Program No. 6506000 CS 0101 R BL 604 G SR 90 ~ Grant County Line to Ritzville ~ Wahl Rd. Overcrossing

C.S. 0101, SR-90, L-2323
Grant Co. Line to Ritzville
Wahl Road Overcrossing Sta 971
FA No. I-90-4( )
Foundation Investigation

FOUNDATION DESIGN RECOMMENDATIONS

FOUNDATION PROFILE

ELEVATION - NORTH BRIDGE

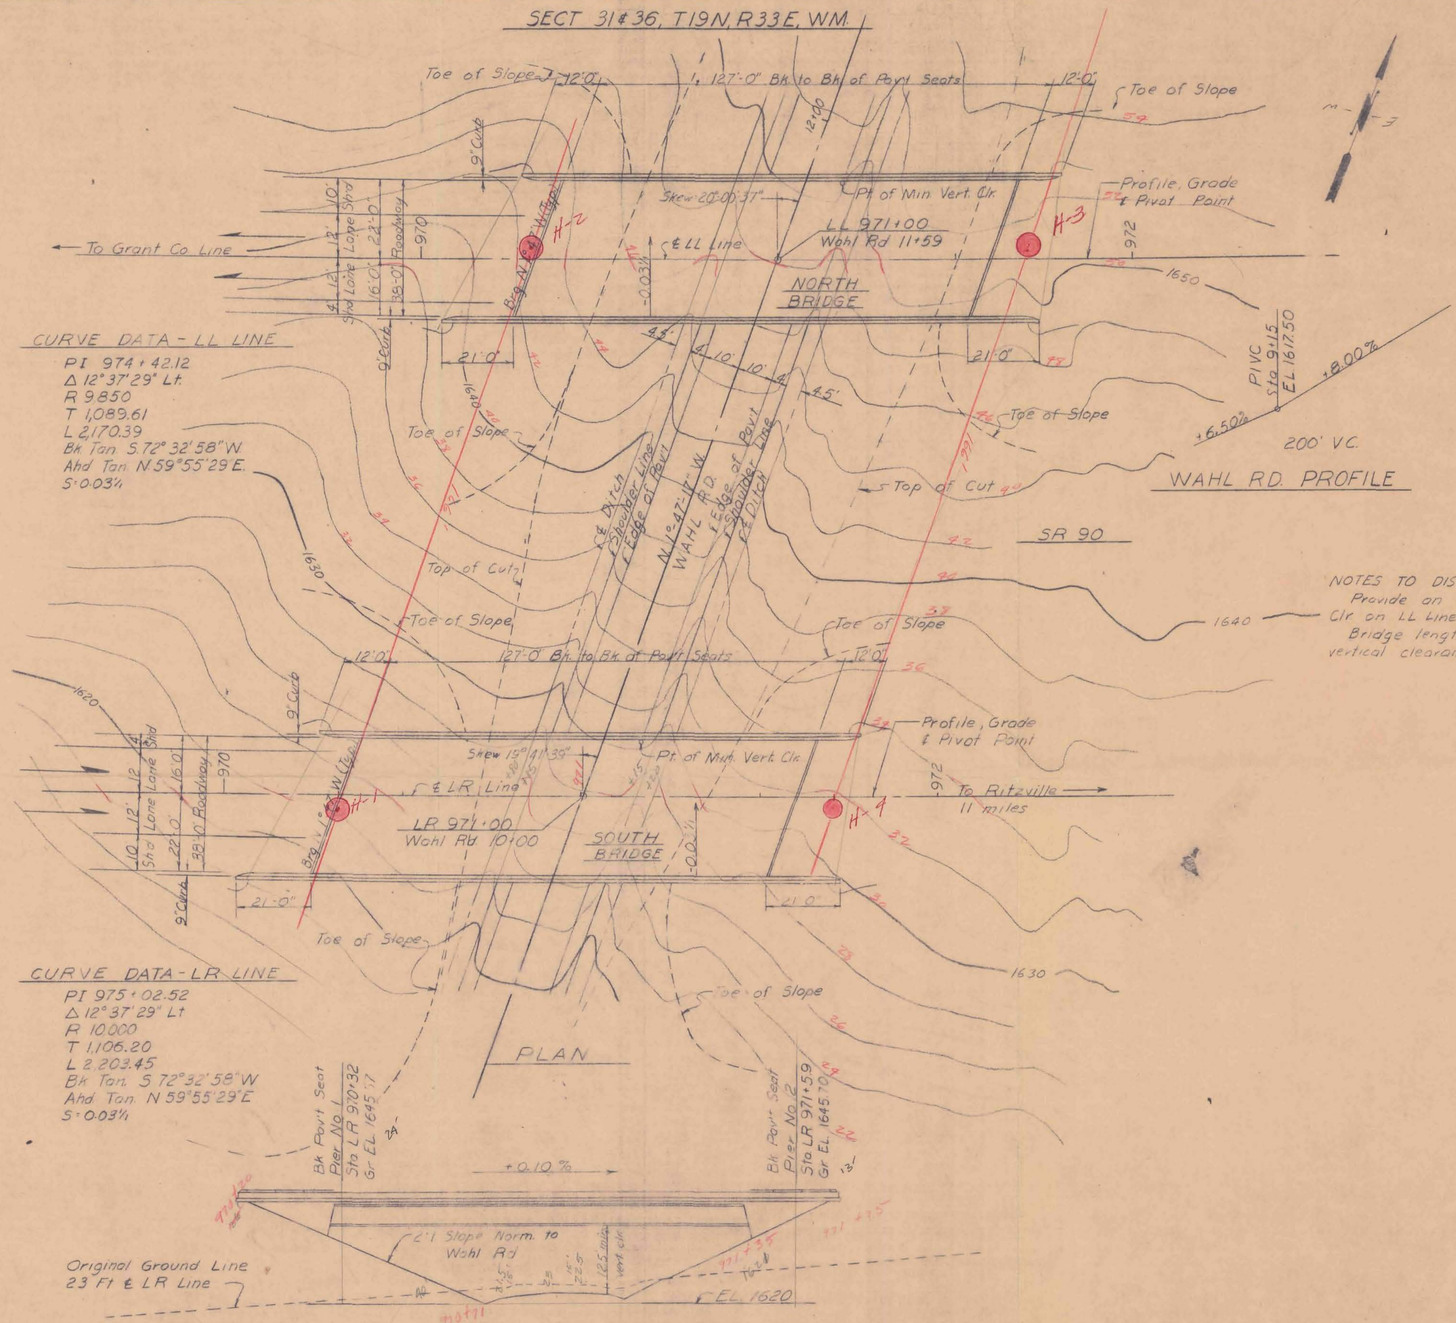
NOTES TO DISTRICT:
Provide an additional 2.4' of Vert Clr on LL Line & 2.0' Vert Clr on LR Line. Bridge length is based on 14.5' vertical clearance.

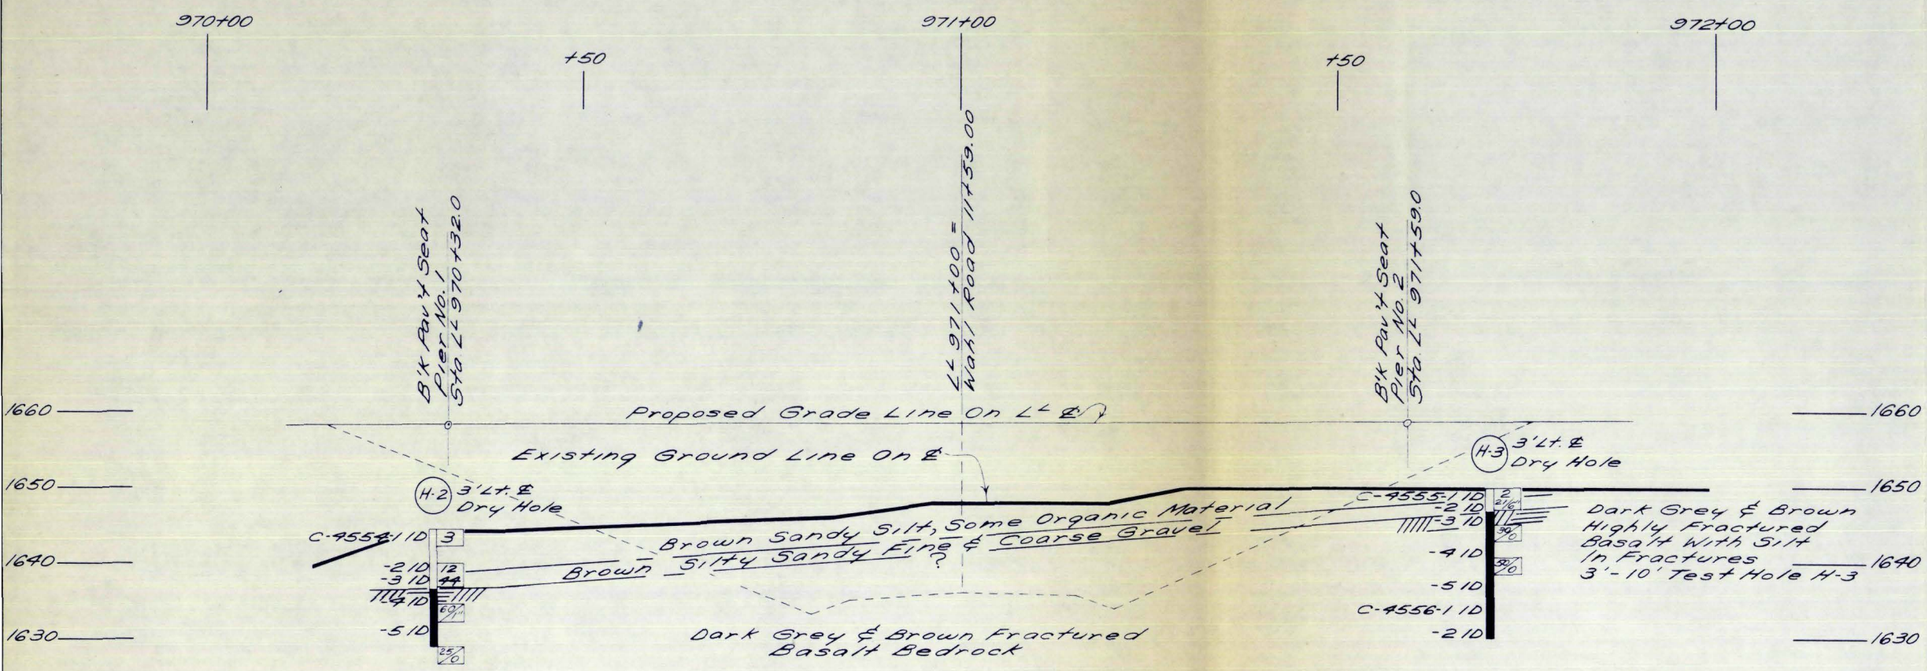
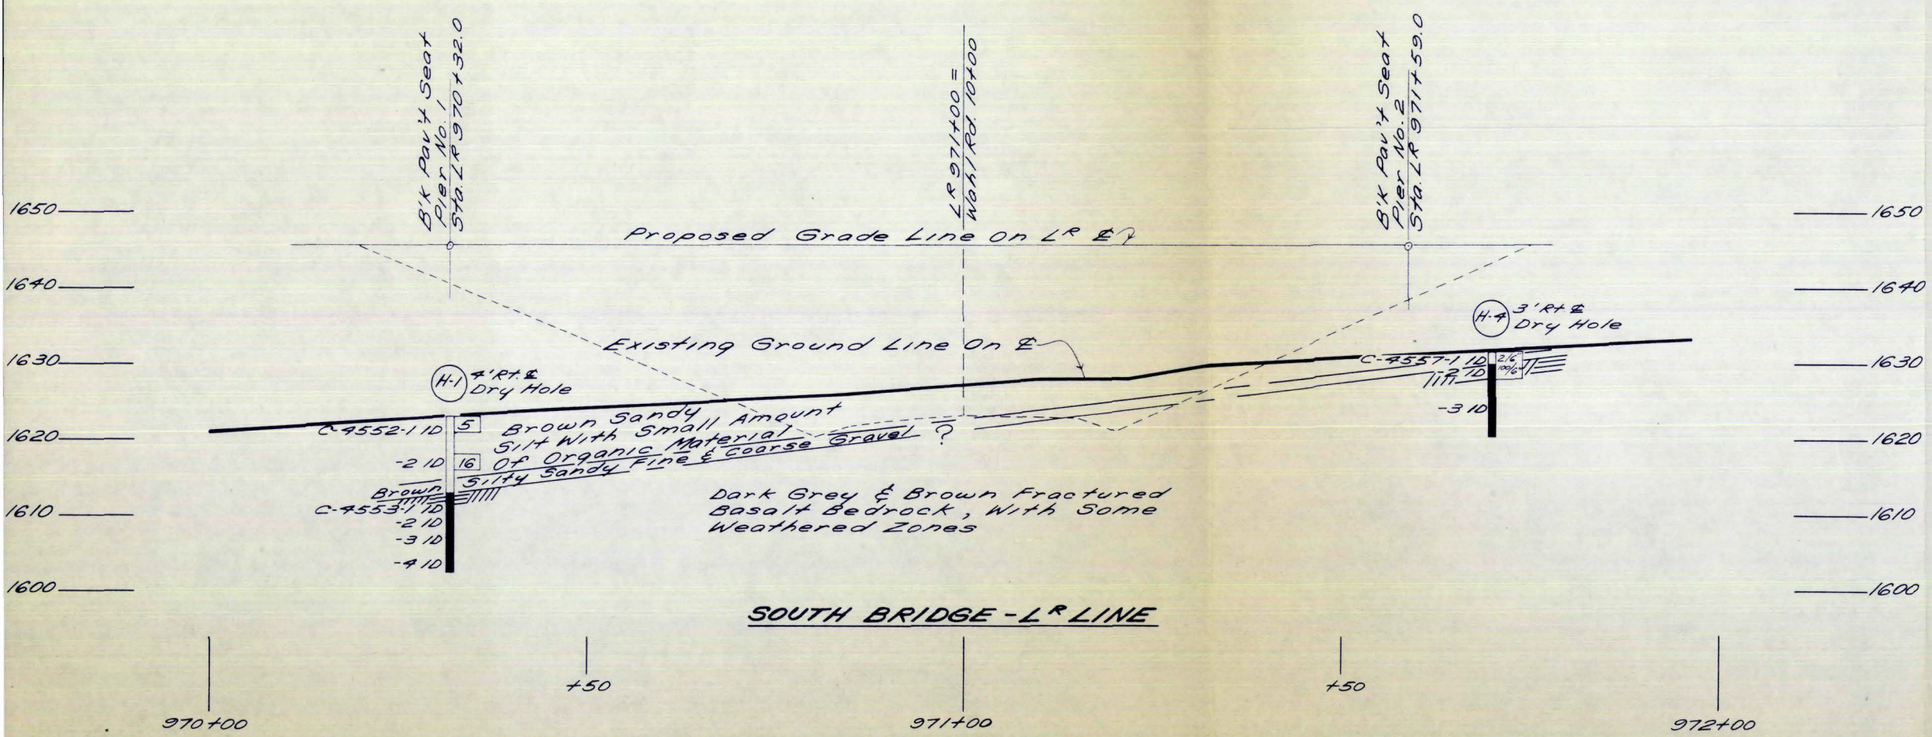
Four test holes were drilled in order to determine the foundation conditions for the subject twin structures. The test hole locations and the foundation soil stratification are shown on the attached soil profile.

The foundation material consists of fractured basalt bedrock overlain by from 2 to 10 ft of loose sandy silt.

Because of the sloping surface of the bedrock (north to south), spread footings at piers 2-N and 2-S should be stepped or sloped. Complete foundation recommendations are detailed on the attached foundation recommendation sheet.

The two structures may be supported by spread footings with bearing values of 3 to 10 tsf placed at the elevations shown on the attached recommendation sheet, provided the loose sandy silt is removed to a depth of 8 ft in the vicinity of piers 1-N and 1-S and backfilled with good quality granular material compacted to 95 percent of maximum density as determined by Section 11-3.13E5 of the Standard Specifications. It will also be necessary to construct the west approach embankments out of similar material with the same density requirement. Removal should extend full depth over an area which extends 5 ft in front and 5 ft in back of the pier including the retaining wall sections. In order to reduce the possibility of a bump developing at the transition from no removal to full removal, the end of the removal cavity should be tapered on a 10:1 slope. Since the spread footings at piers 2-N and 2-S will be placed on bedrock, special embankment compaction is not needed.

The removal as recommended at piers 1-N and 1-S and the bedrock foundation at piers 2-N and 2-S will insure stable embankments at the four approaches with little or no settlement at the bridge ends.
